Access Compliance Report

Public Rights-of-Way

(Curb Ramps)

Intersection ID: 20292	Main Street: BENTLEY_OAKS_LN	Cross Street: SARDIS_RD	Location: NE
ADA ID: FFD421989681	Ramp Type: Perp	Initial Pass/Fail: Fail	Overall Compliance: No
Severity Score: 13.75			
Codes/Mitigation Info/Possible Solution		Field Measurements/Component Compliance

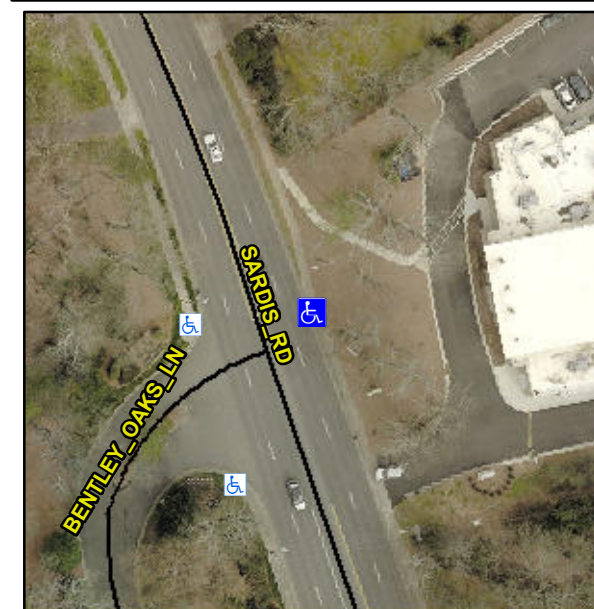
Not Found, R304.2.2

Compliance	Description	Data	Compliance	Description	Data
N/A	Ramp Length (in)	60.0	No	Ramp Slope (%)	9.2
Yes	Ramp Width (in)	49.0	Yes	Ramp XSlope (%)	3.0
N/A	Flare Type LT	N/A	N/A	Flare Type RT	N/A
N/A	Flare Slope LT (%)	N/A	N/A	Flare Slope RT (%)	N/A
N/A	Flare Traversable LT?	N/A	N/A	Flare Traversable RT?	N/A
N/A	Landing Length (in)	N/A	N/A	DWS Provided?	N/A
N/A	Landing Width (in)	N/A	N/A	DWS Contrast?	N/A
N/A	Landing Slope (%)	N/A	N/A	DWS Length (in)	N/A
N/A	Landing X Slope (%)	N/A	N/A	DWS Full Width?	N/A
N/A	Landing Curb? (Y/N)	N/A	N/A	DWS Offset (in)	N/A
N/A	Shared Landing?	N/A			
N/A	Gutter Ponding?	N/A	N/A	Gutter Slope (%)	N/A
N/A	Gutter Lip Ht (in)	N/A	N/A	Gutter X Slope (%)	N/A
N/A	Painted X Walk1?	No	N/A	Painted X Walk2?	N/A
	X Walk 1 Direction	To W		X Walk 2 Direction	N/A
N/A	X Walk 1 Width (in)	N/A	N/A	X Walk 2 Width (in)	N/A
	X Walk 1 Slope (%)	0.1		X Walk 2 Slope (%)	N/A
	X Walk 1 X Slope (%)	3.4		X Walk 2 X Slope (%)	N/A

Remove & Replace Entire Ramp.
